SUBJECT: Forwards request for relief from Section X1 of ASME Boiler & Pressure Vessel Code re inservice insp. Request submitted due to impracticality of hydrostatically testing specific welds following maint or mod as Code requires.

Duke Power Company
Oconee Nuclear Station - Unit 3
Request For Relief from Inservice
Inspection Requirements (Hydrostatic)

ISOMETRIC SKETCH

PROJECT OCONEE SYSTEM 04A SUB SYSTEMS (1) UNIT 3BB ISO. NO. 29 REV. NO. 8
 CLASS F MATERIAL CFE WELDING PROCEDURE PA P5B LAST WELD NO. 29 DATE 8-27-25

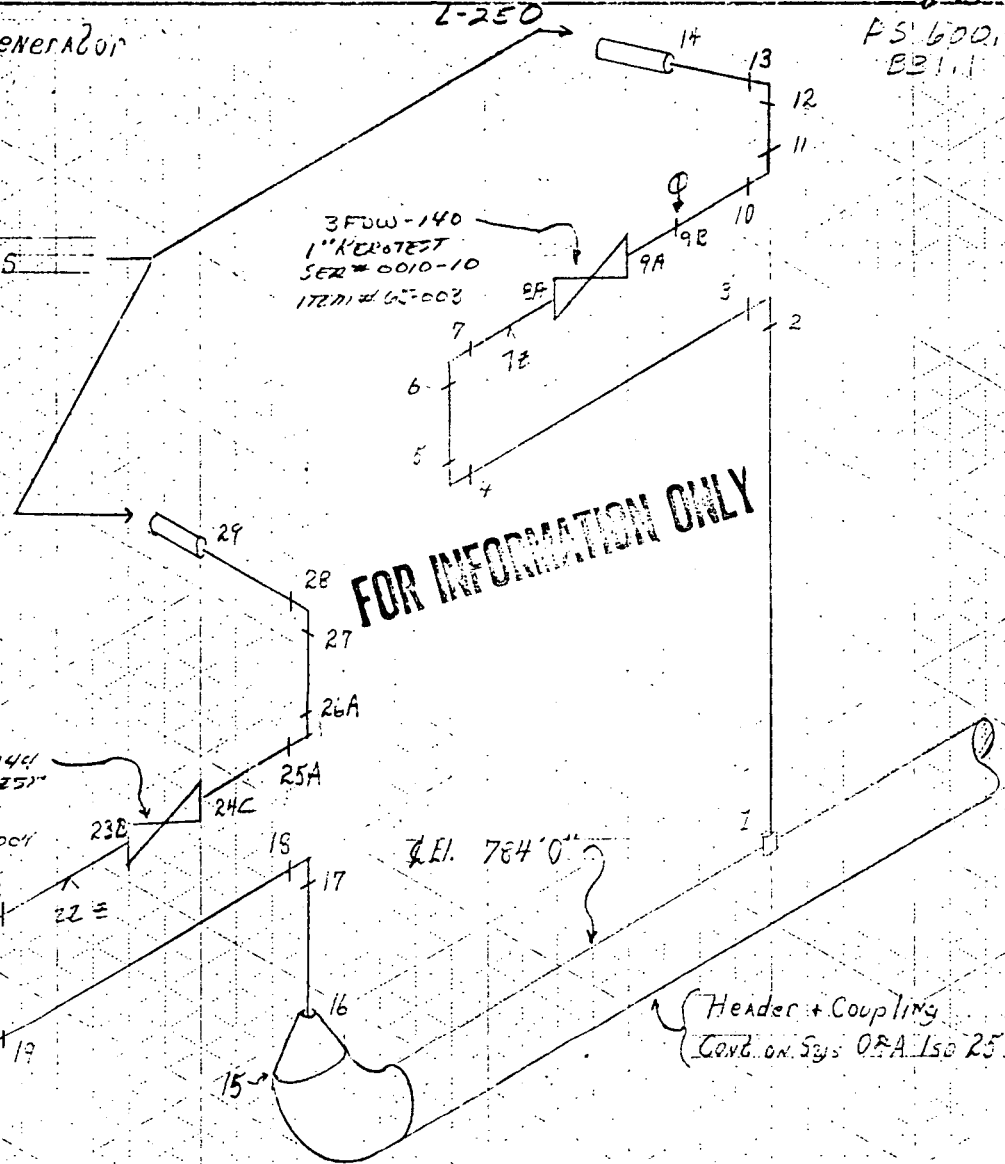
To perform the required hydrostatic test on welds 24C, 25A, and 26A (shown on the attached isometric sketch) would require the filling of the Steam Generator and Main Steam Lines up to the stop valves with water.

Therefore, based on the above discussion, Duke requests that the Steam Generator Drains between 3A OTSG and 3FDW-144 be considered exempt from the requirements of Section XI, paragraph IWA-4400(a).

- (a) The welds will be penetrant tested, then examined during the system pressure test prior to Unit 3 startup.
- (b) The welds will also be inspected during the OTSG/MS line hydro as part of the Inservice Inspection Plan.

- (a) Penetrant testing and visual testing will be done prior to Unit 3 startup.
- (b) Hydrostatic testing will be performed during 10 year Inservice Inspection.
